Docket Number:	15-AFC-01
Project Title:	Puente Power Project
TN #:	215780
Document Title:	State Coastal Conservancy Comments: On Concerns Regarding the Puente Power Project
Description:	N/A
Filer:	System
Organization:	State Coastal Conservancy
Submitter Role:	Public Agency
Submission Date:	2/6/2017 3:11:05 PM
Docketed Date:	2/6/2017

On Concerns Regarding the Puente Power Project

Re: Puente Power Project, Application for Certification 15-AFC-01

SANTA CLARA RIVER ESTUARY VISION
BASEMAP - Setback Levee Conditions

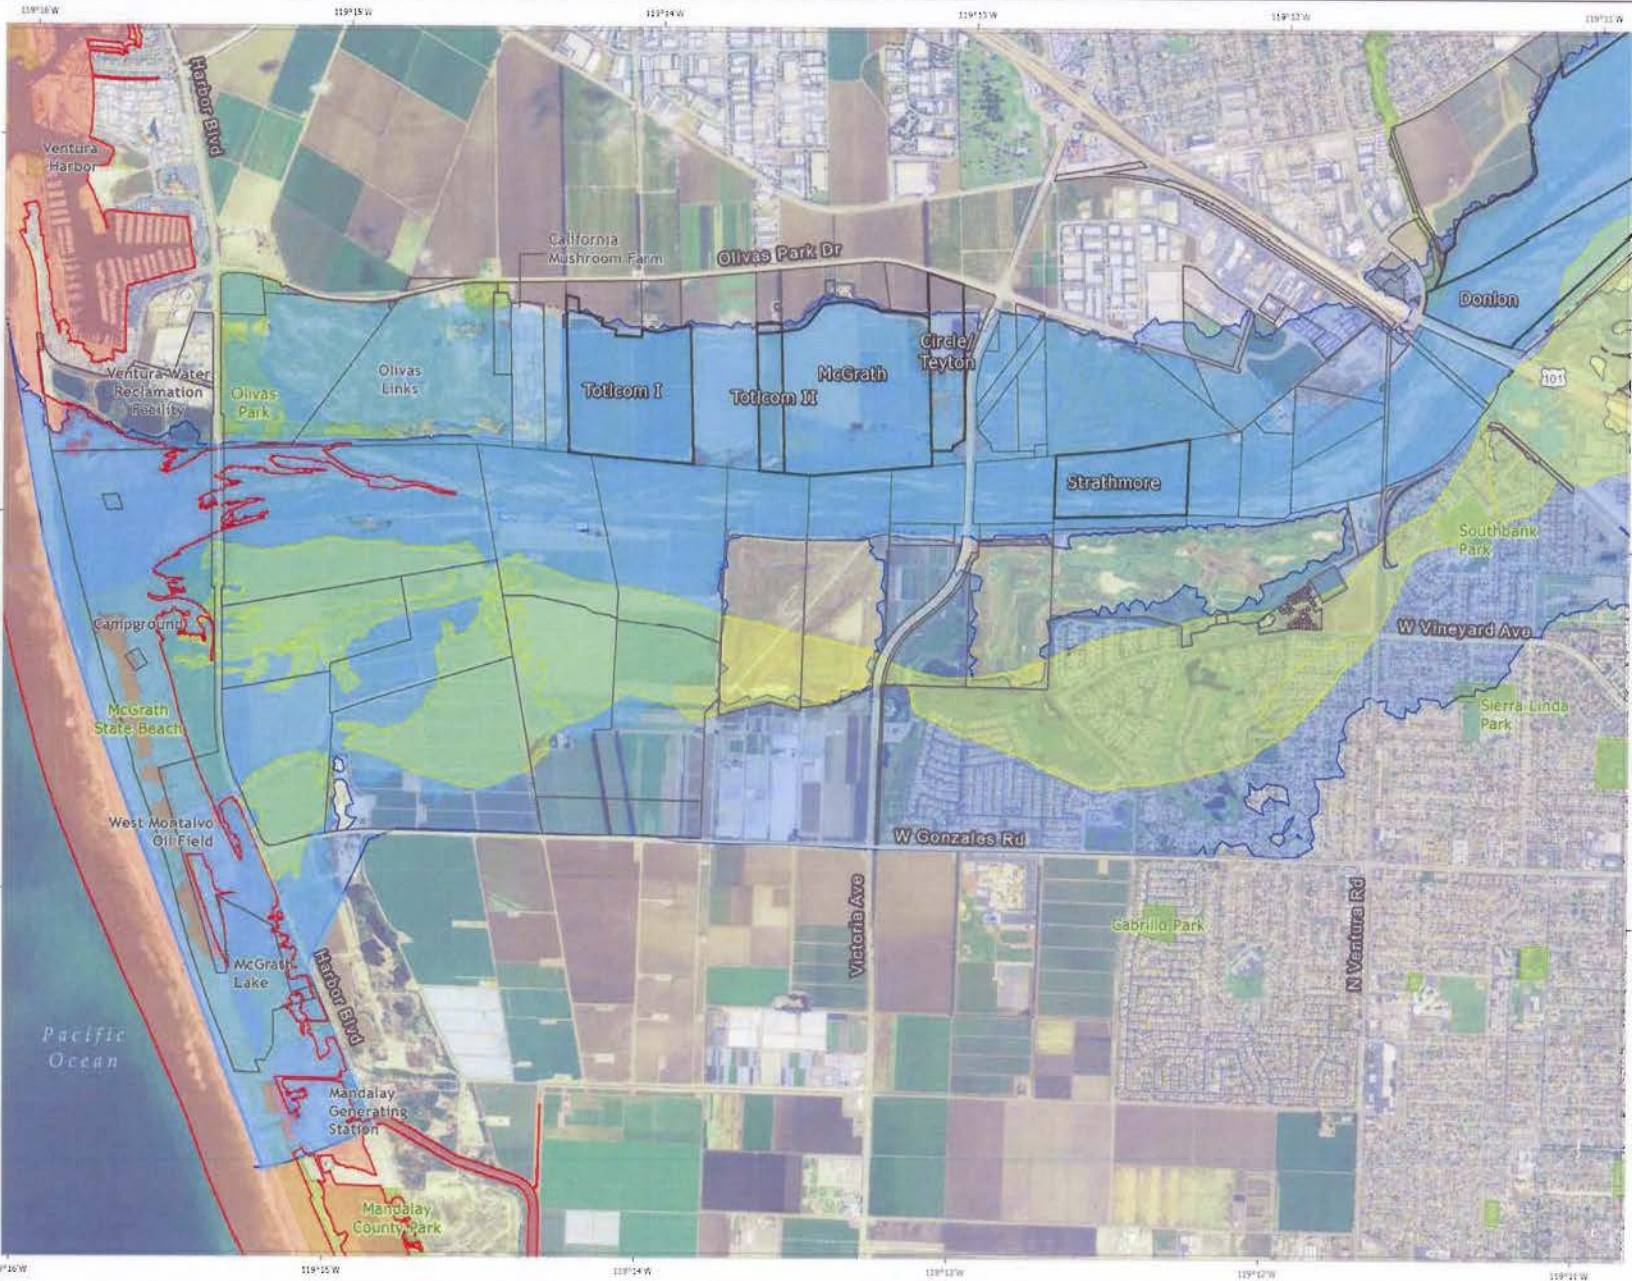
Santa Clara River Parkway: Since 2001, the Conservancy has granted over \$15 million for acquisitions along the Santa Clara River. In addition, the Conservancy contracted for a geomorphic assessment of the Santa Clara River watershed, including where the river meets the Pacific Ocean. That report assessed and mapped the potential for flooding in the lower channel as well as the potential for restoration efforts in this area. Attached to this letter is a more detailed map of the modeled flooding from a 25-year and 100-year flood event. This is part of the same report cited in the Coastal Commission’s report to this body.³ In order to provide the Commission with accurate information concerning this mapping effort, we asked our contractor, Stillwater Sciences, to clarify the model result for the Mandalay station. Zooey Diggory (MS) of Stillwater Sciences related that the mapping assumed existing levee conditions and did not consider sea level rise in its evaluation. The analysis found flooding would occur at Mandalay station of up to 4ft for a 100-year flood event.⁴ Ms. Diggory stated, “it can be reasonably assumed that the Q100 flow event with sea

level rise (which was not modeled specifically) would result in even deeper and longer duration of flooding at Mandalay.”⁵

power plants to be sited in the geomorphically active coastal zone of the Santa Clara River and suggests inland sites should be more carefully considered as viable alternatives to meet this region's electric power needs.

Accordingly, the Coastal Conservancy recommends that the Commission require NRG to relocate the proposed project to an alternative site away from the coast as suggested by the Coastal Commission’s report, p. 17 and the City of Oxnard.⁷ As a sister agency to the Coastal Commission, we support the efforts of NRG to move away from once-through cooling technology. This effort decouples the need for
